REQUEST FOR DRB APPROVAL FOR:
PRICE RESIDENCE

DRB21-0722
REVISED FINAL SUBMITTAL 11/22/2021
NOVEMBER 2021 AGENDA

1649 W 22ND STREET, MIAMI BEACH, FL 33140

NORTHEAST FACADE
AS SUBMITTED
NTS

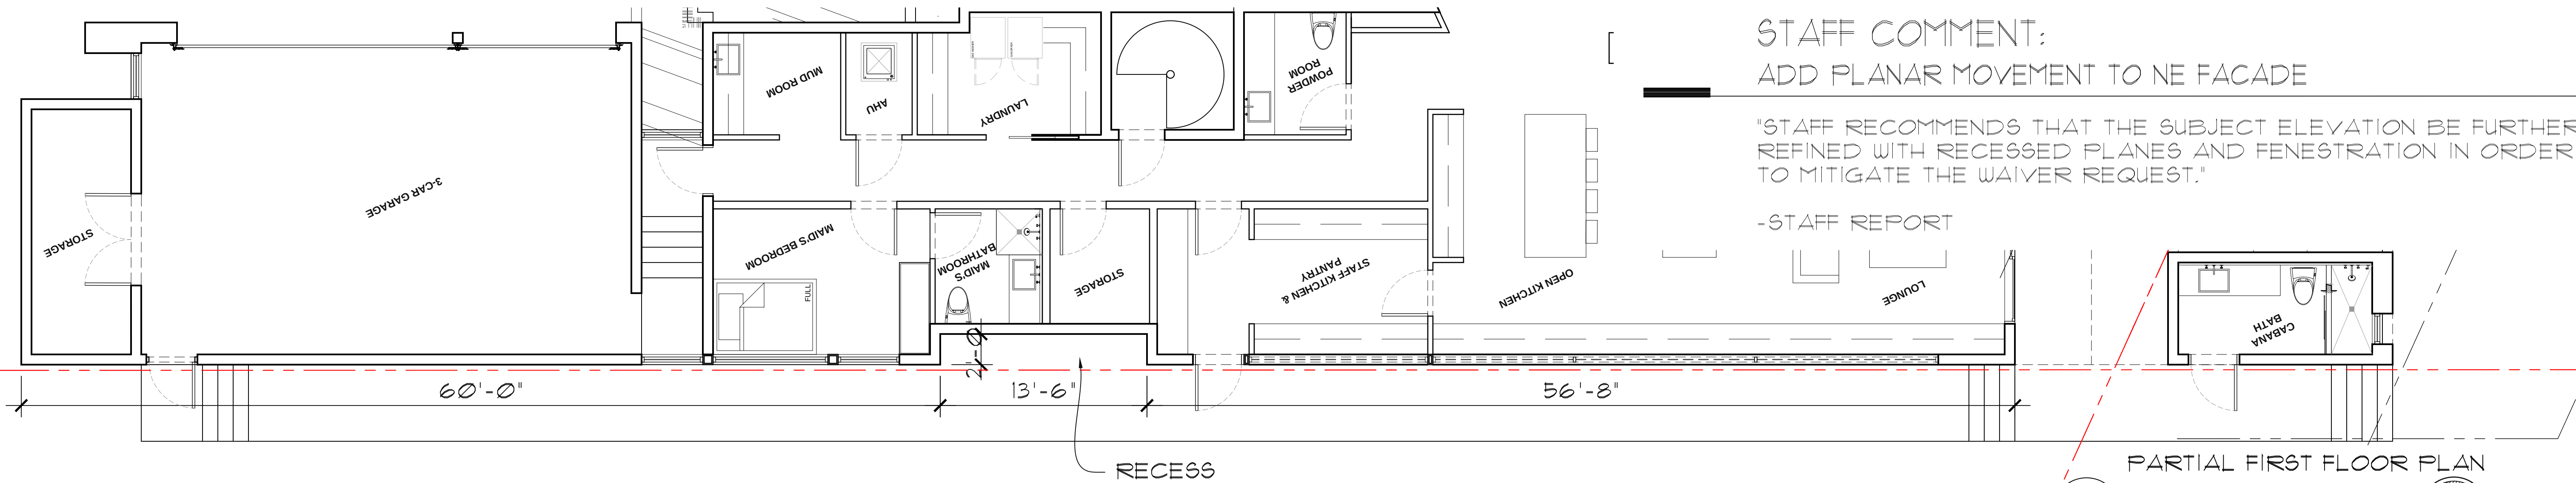
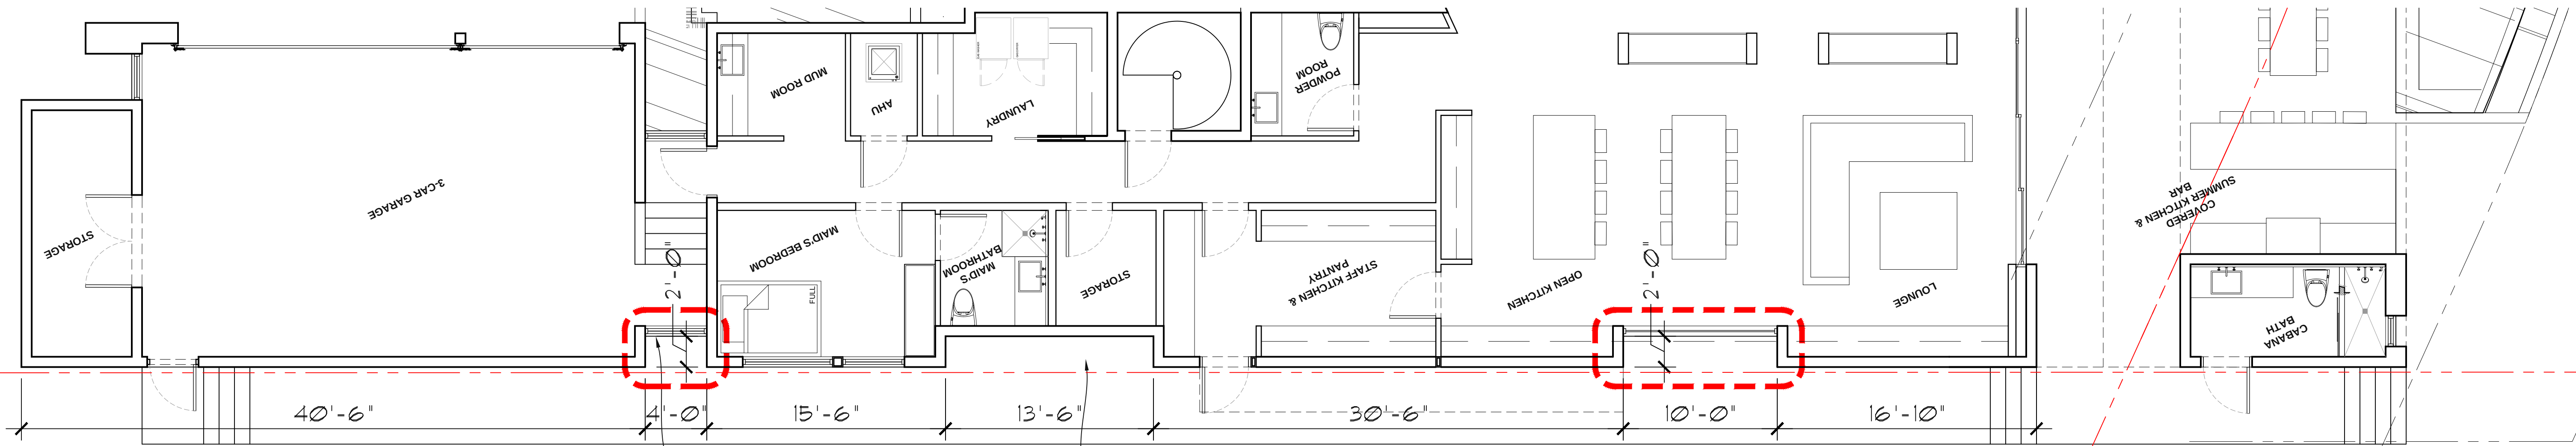
STAFF COMMENT:
ADD PLANAR MOVEMENT TO NE FACADE

"STAFF RECOMMENDS THAT THE SUBJECT ELEVATION BE FURTHER REFINED WITH RECESSED PLANES AND FENESTRATION IN ORDER TO MITIGATE THE WAIVER REQUEST."

NORTHEAST FACADE
MODIFIED
NTS

PARTIAL SECOND FLOOR PLAN

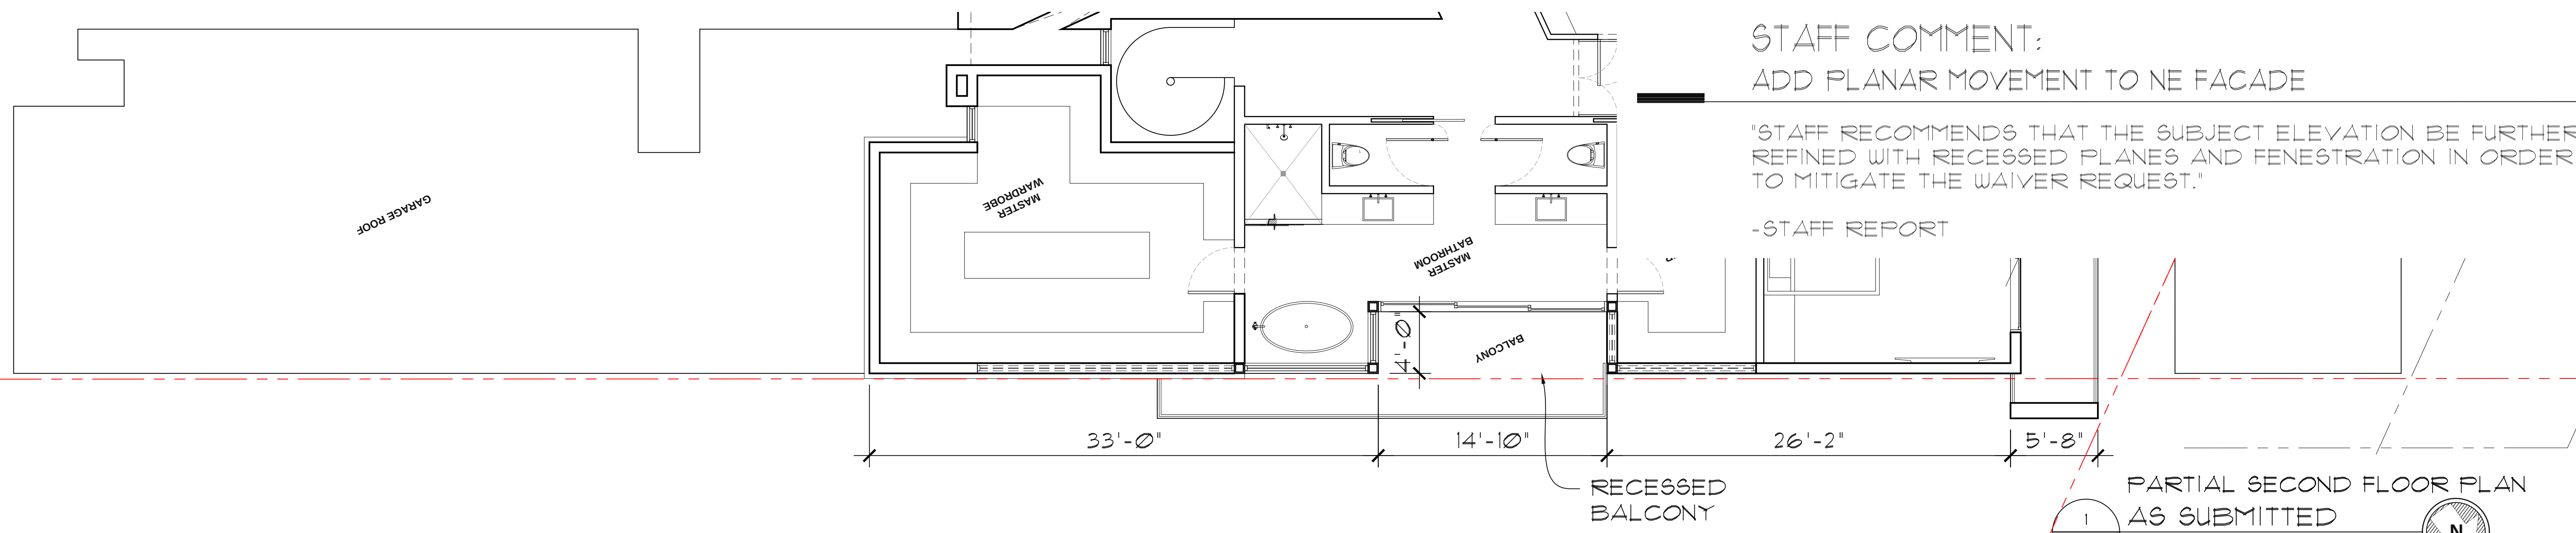
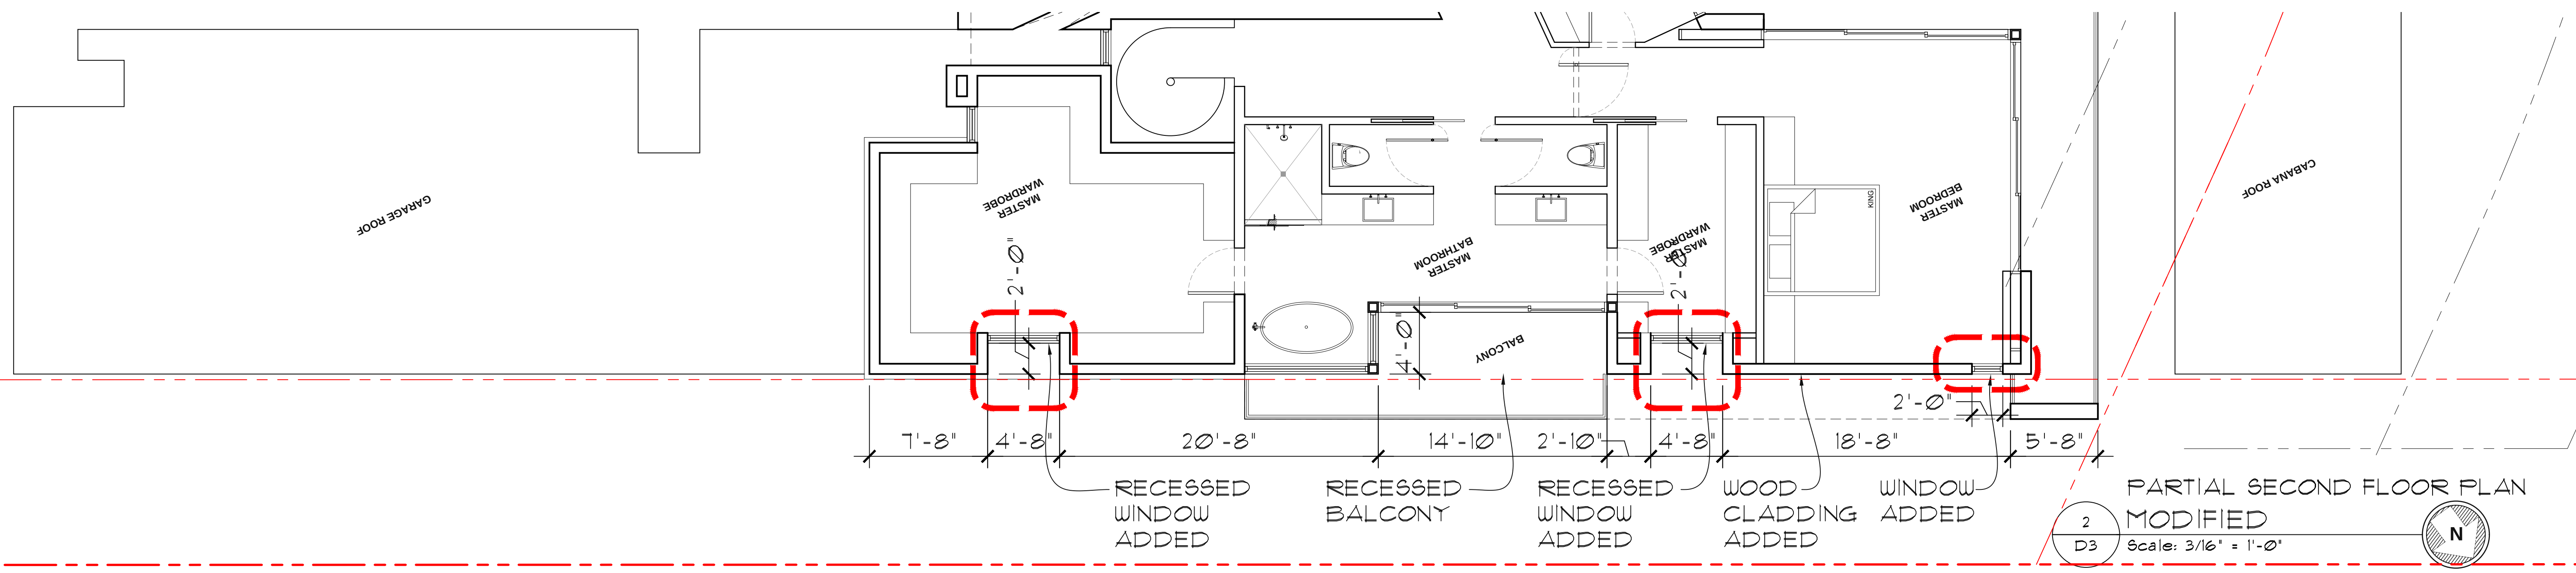
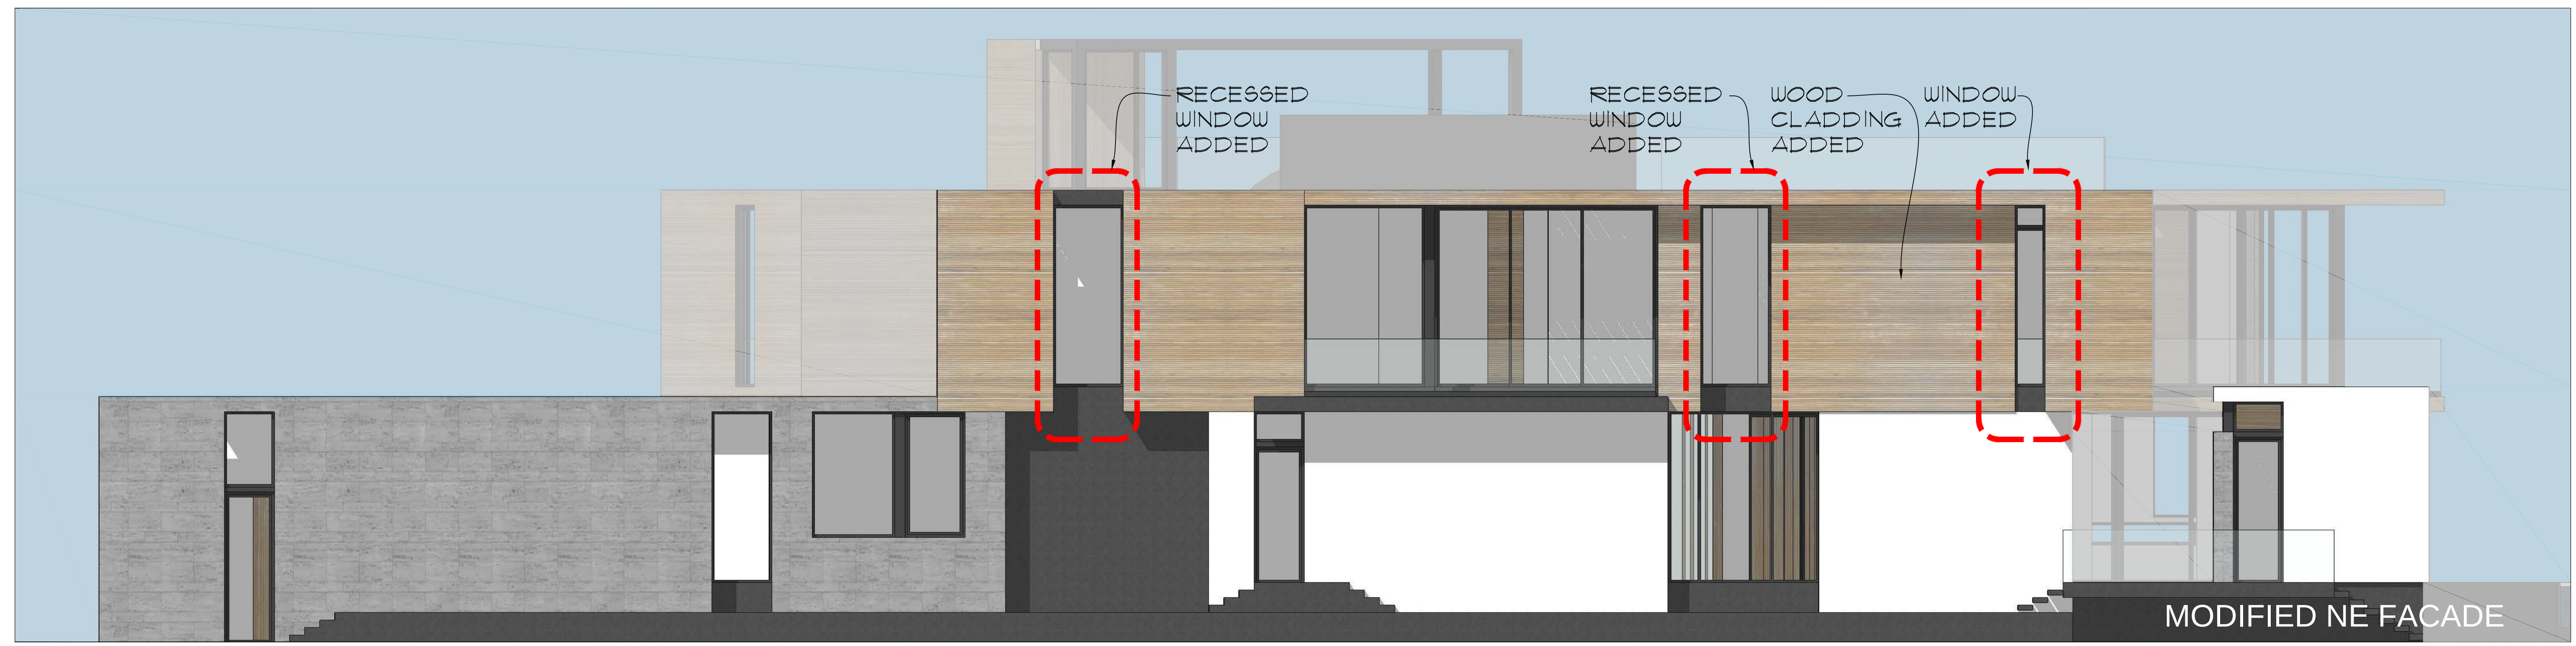
STAFF COMMENT:
ADD PLANAR MOVEMENT TO NE FACADE

"STAFF RECOMMENDS THAT THE SUBJECT ELEVATION BE FURTHER REFINED WITH RECESSED PLANES AND FENESTRATION IN ORDER TO MITIGATE THE WAIVER REQUEST."

2 MODIFIED
D3 Scale: 3/16" = 1'-0"
